ZONING COMMISSION
District of Columbia
CASE NO. 01-28 TE
EXHIBIT NO. 72

RE: Pre-Hearing Submissions Requested by the Office of Planning,
ZC Case No. 01-28TE (PUD Modification & Time Extension-200 K Street N.E.)

SITE TABULATIONS & BUILDING CALCULATIONS
(Revised 9/29/05 in response to Office of Planning recommendations)

1 MASSING PLAN
SCALE: 1" = 80'-0"

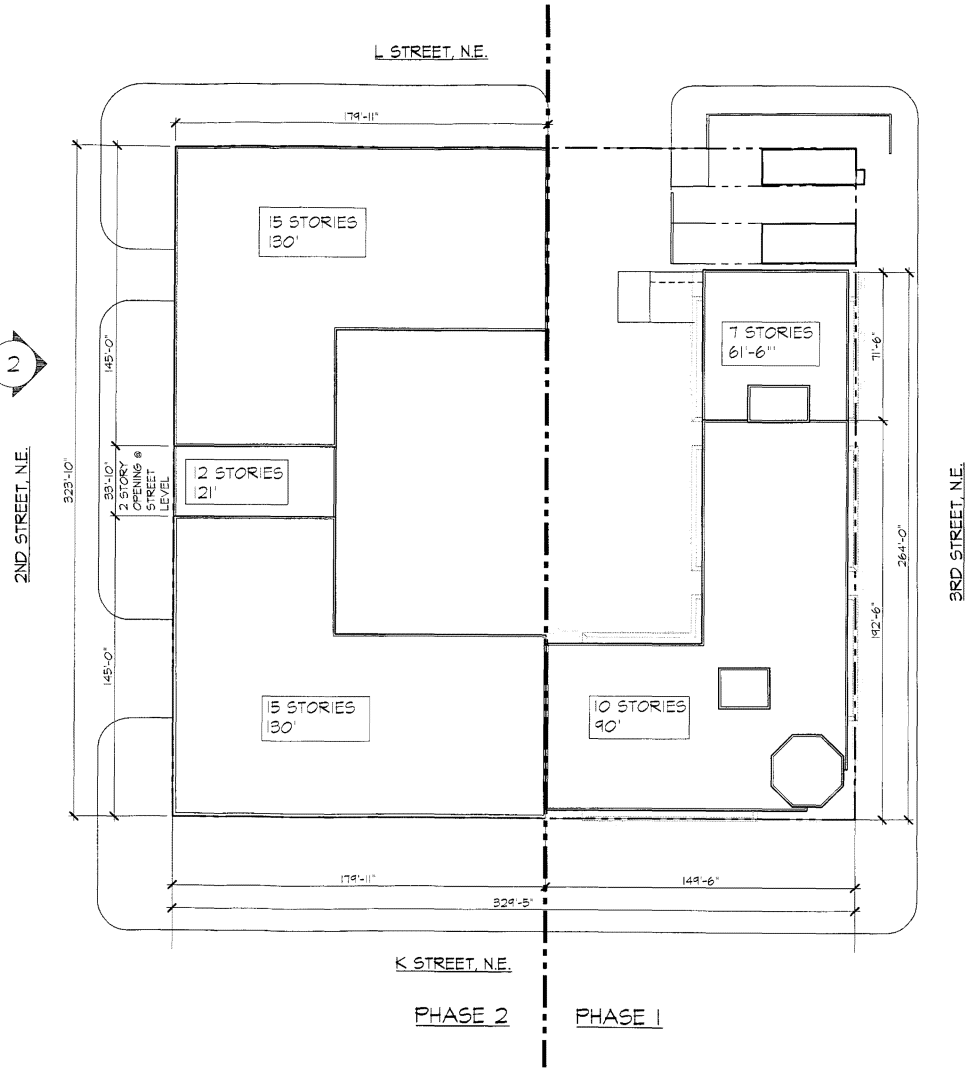
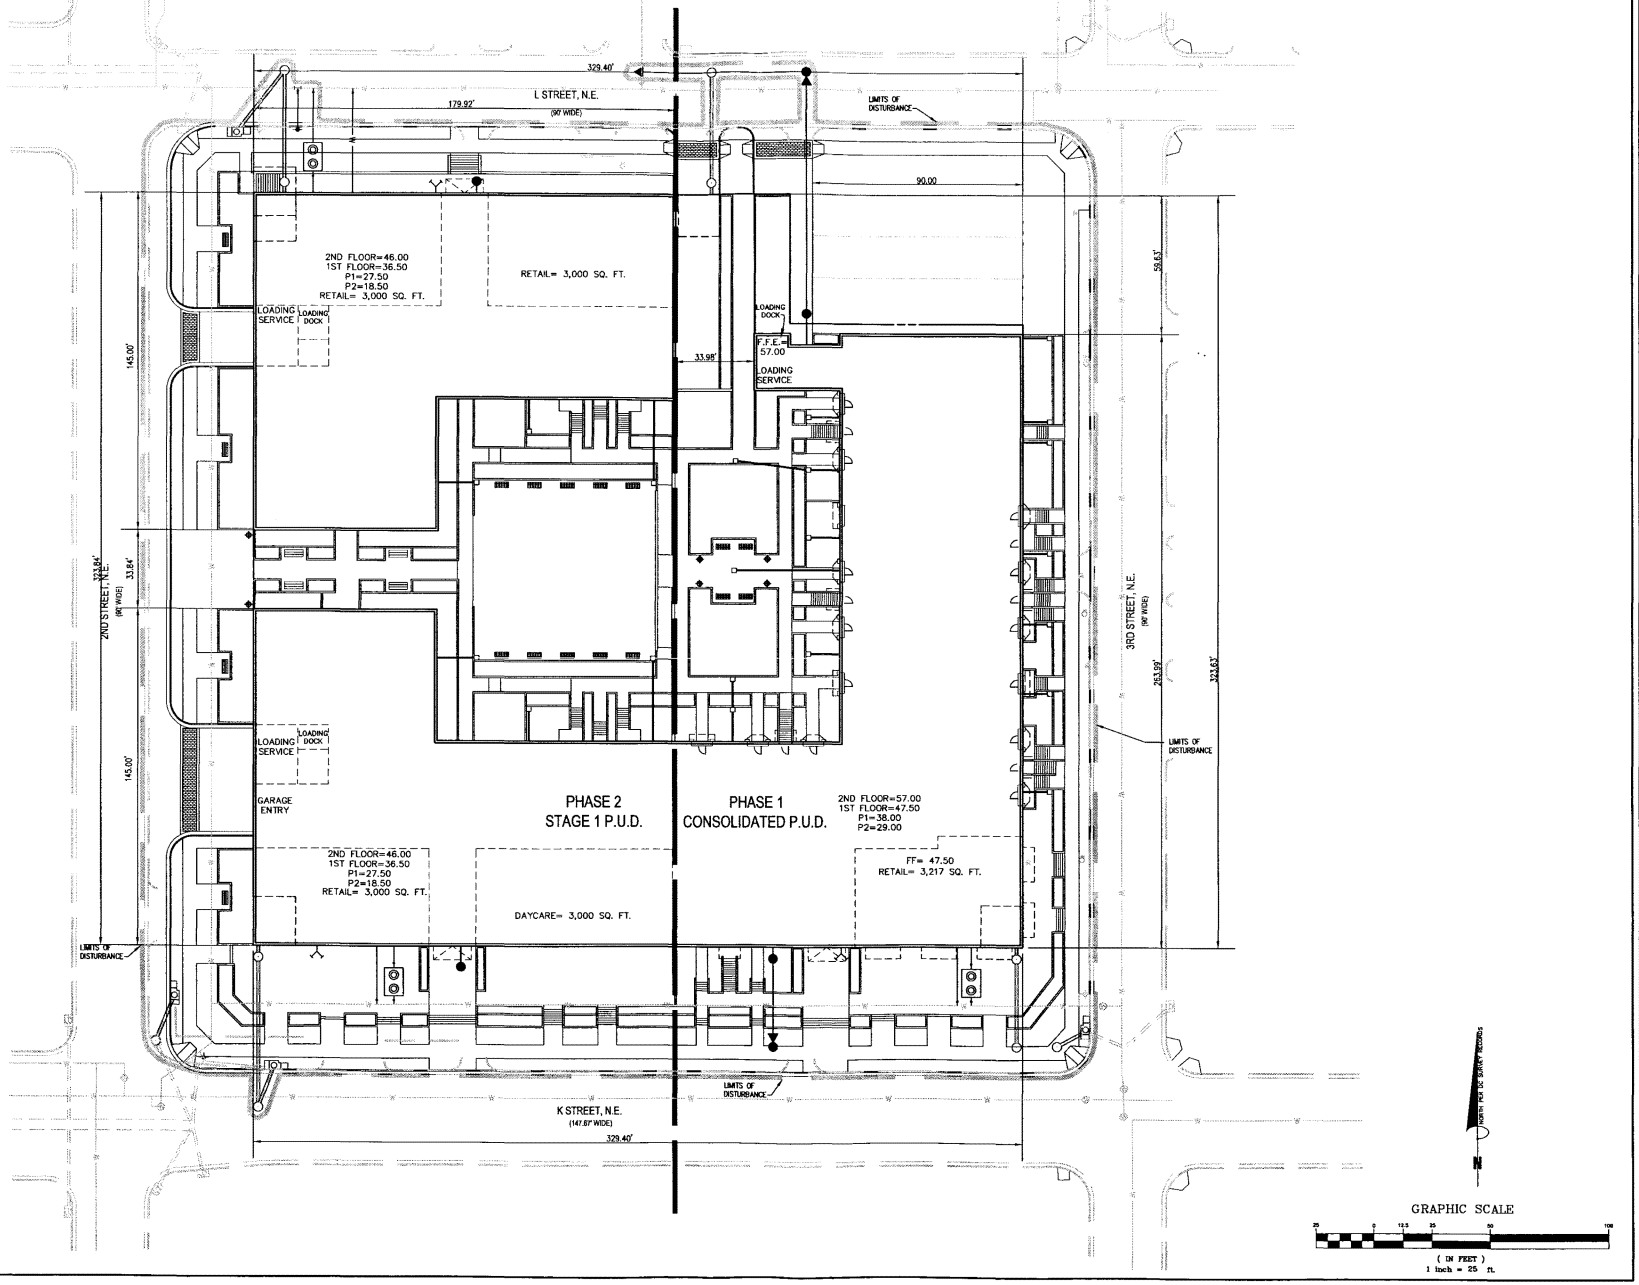
OP/b. Revising the site plans and, if necessary, the square footages, FARs etc., for the Preliminary PUD modifications to either:

i. Reduce the height of the building shown at 2nd and L Streets to 110', in conformance with the Height Act of 1910, or;
ii. Re-design the site plan and massing of the Preliminary PUD so that it is clearly one building that, for the purposes of the Height Act, fronts on K Street.
This is necessary because, as noted earlier, while the approved PUD did apparently allow for a 130 foot building that has frontage only on two 90-foot streets (2nd Street and L

Street), the Height Act does not permit this. Of the street frontages within this PUD, only K Street is wide enough to permit buildings of 130 feet. *(Prior to hearing)*;

Applicant Response: The Applicant has chosen to exercise the second option, redesigning the site plan and massing of the Preliminary PUD to create one building fronting on K Street, as illustrated in the architectural drawings included as Attachment 4. ***[See particularly,*** Sheet C.1.1 Massing Plan & 2nd Street Elevation Diagram.] According to data provided by OP, K Street measures approximately 147 feet in width; thus, with a single building fronting on K Street, the proposed building height of 130 feet complies with the Building Height Act.

As previously designed, the Preliminary PUD consisted of two L-shaped buildings. One had its street entrance fronting on K Street; the other had its street entrance fronting on L Street. The two buildings were structurally separate, but visually linked into a cohesive whole by a landscaped pedestrian walkway leading from 2nd Street, between the two structures, into the central plaza and additional entrances to each building.

The re-design preserves the landscaped pedestrian walkway from 2nd Street – an essential element to assure public access to the central plaza. The pedestrian walkway – approximately 33 feet in width and extending about 18 feet from the street into the central plaza – is maintained through the second-floor level of the building to perpetuate an inviting sense of airy openness. At the third-floor level and above, the re-design provides 12 floors of structural linkage, merging the two buildings into one, with its main street entrance on K Street.
